Groundwater Application Review Summary Form

Review of Water Right Application G-18763

TO:		Water	Rights S	ection		Date2/6/2019							
FROM	: "			ection		Aurora C Bouchier							
						Reviewer's Name							
SUBJE	ECT:	Appli	cation G-	18763		Supersedes review ofna							
										Date o	f Review(s)		
PUBL	IC INT	EREST	PRESU	MPTION;	GROUNI	DWATE	<u>R</u>						
OAR 69	90-310-1	30 (1) 7	he Depart	ment shall p	resume that	a propos	ed groundv	vater use will e	ensure the	preservati	on of the pu	ıblic	
								w groundwate					
								the proposed agency poli					
			RMATIO					Kerri Arnzen					
A1.								Willamette					
		Molalla-	Pudding			subb	asin						
A2.	Propose	ed use _	Irri	gation (16.20	6 acres)	Seas	sonality: _	March 1 – Oct	ober 31				
A3.	Well ar	nd aquife	er data (att	tach and nu	mber logs f	or existin	g wells; m	ark proposed	wells as	such under	logid):		
Well	Logi	d	Applicant Well #	's Propos	ed Aquifer*	Prop		Location (T/R-S QQ-			netes and bo		
1	MARI 6:	MARI 65642 1 Alluvium		lluvium	Rate(cfs) (T/R-S QQ 0.20 6S/2W-22 N					00' W fr NE co

Water-Level Trends in Nearby Wells

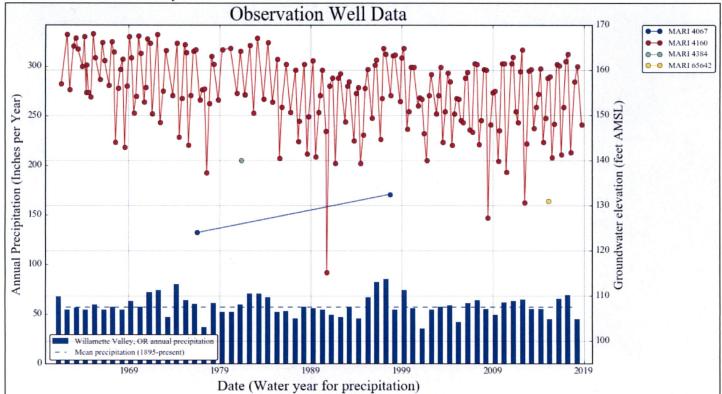
c.	Condition to allow groundwater production only from the groundwater reservoir between approximately ft. and ft. below land surface;
	issuance of the permit until evidence of well reconstruction is filed with the Department and approved by the Groundwater Section. Describe injury —as related to water availability—that is likely to occur without well reconstruction (interference w/ senior water rights, not within the capacity of the resource, etc):
	bundwater availability remarks:
Silt 10-2	in the vicinity of the subject wells. Seasonal water-level fluctuations in the sand and gravel aquifer are estimated to be 20 feet/year based on the hydrograph for MARI 4160 a nearby observation well (located approximately 2 miles to the t-northwest).

Cross Section/Profile

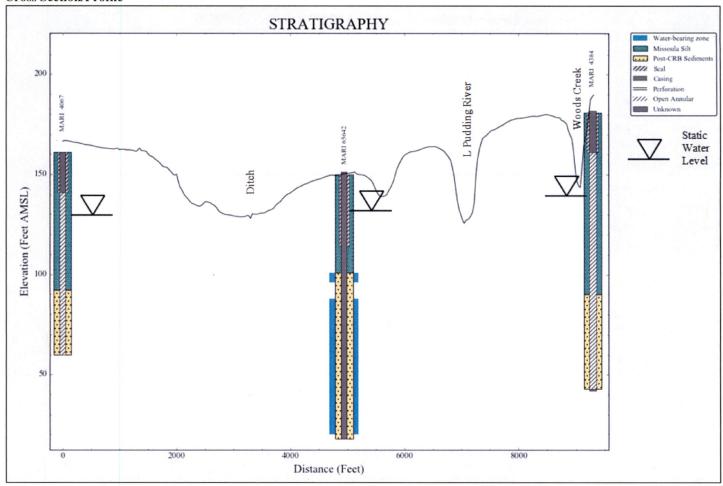
Comments: Potential depletion of Little Pudding River by production at the proposed POA (MARI 65642) was estimated using the Hunt 2003 stream depletion analytical model. Analytical modeling results for the proposed POA shows that estimated interference at 30 days is less than 25% of well production. The thickness of the silt and associated fine-grained sediments in the area between the well and the stream (about 25 feet) was estimated based on maps in Gannett and Caldwell (1998), nearby wells, and land surface elevations from topographic maps (see Cross Section below). Aquifer thickness averages about 100-120 feet in the vicinity of the proposed wells.
